**SUBJECT: Comments on Tentative Waste Discharge Requirements
City of Sacramento Department of Utilities/Sylvia Dellar Survivor's Trust
Dellar Landfill, Sacramento, California**

**ATTACHMENT
COMMENTS ON TENTATIVE WDRs
SYLVIA DELLAR TRUST AND CITY OF SACRAMENTO**

No Construction Zone Engineered Alternative

<p>www.kleinfelder.com</p>	PROJECT NO. 116081	FINAL COVER COMPARISON OF ORIGINAL AND REVISED FINISH GRADE AT NORTH END OF PROPERTY	PLATE
	DRAWN: 09/09/2012		
	DRAWN BY: D. Ross	DELLAR TRUST PROPERTY SACRAMENTO, CALIFORNIA	
	CHECKED BY: T. Crendall		FILE NAME: cross section-1.dwg

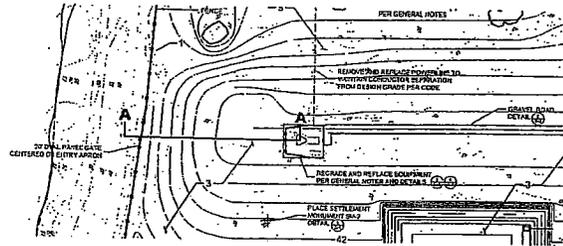
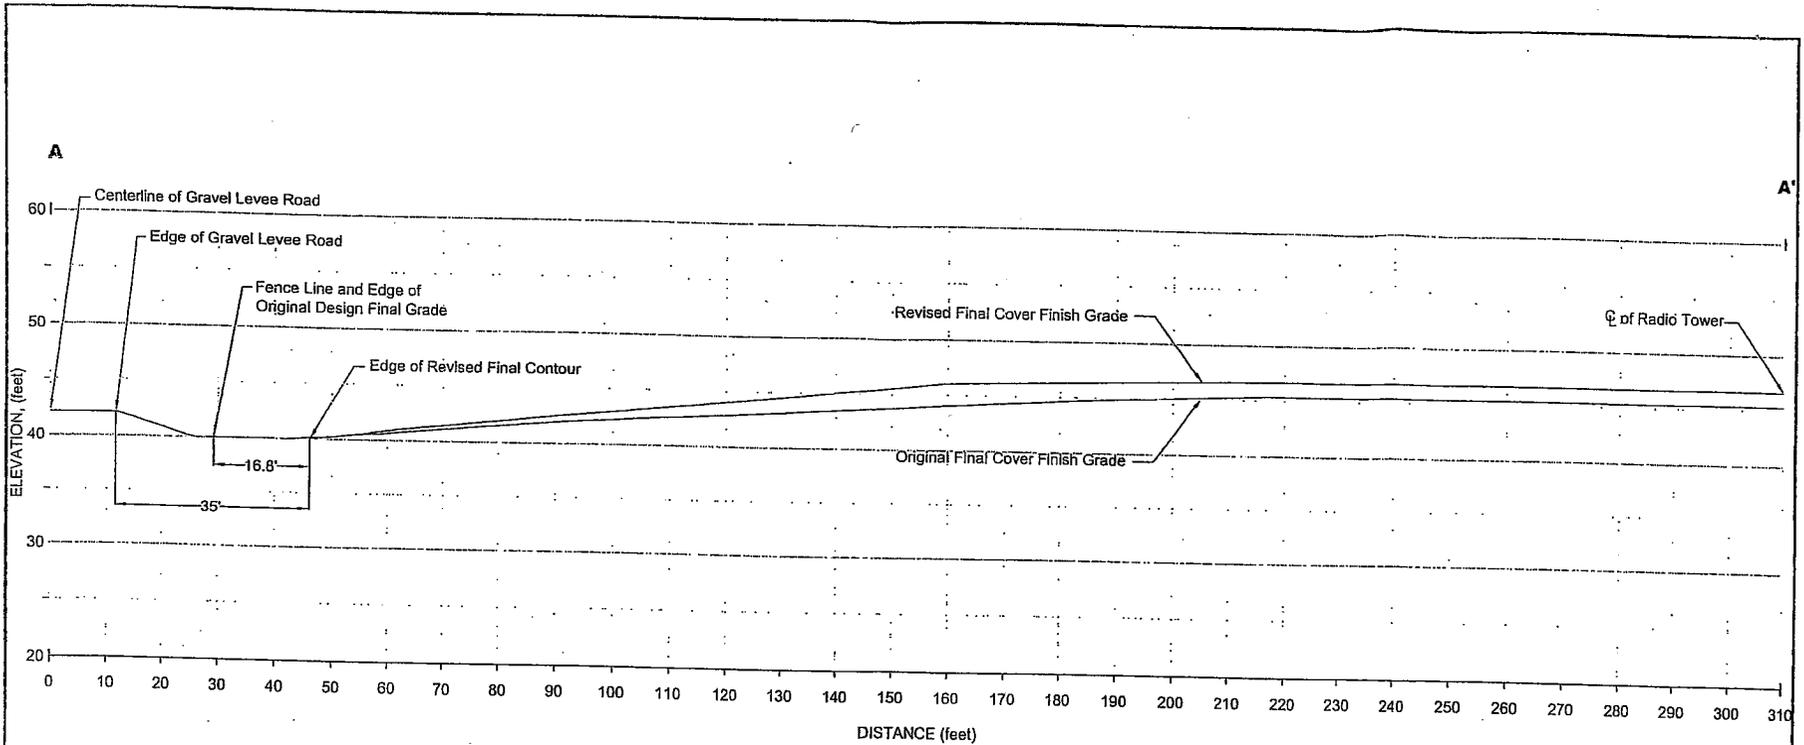
As a result, the northern toe of the final cover was moved as shown in the revised grading plan (Attachment C). This new version of the grading plan also shows some minor topographic changes needed to obtain a better earthworks balance for the project and to improve drainage. Plate 1 (attached) shows a cross-section comparing the original design and the revised design at the northern end of the Dellar property between the radio tower and the gravel levee road. There is little difference between the original design and the revised design.

We have continued with construction using the revised grading plan. I have been instructed by the Trustee to request your written approval of this modification to the grading plan. This letter is subject to the limitations in Attachment D.
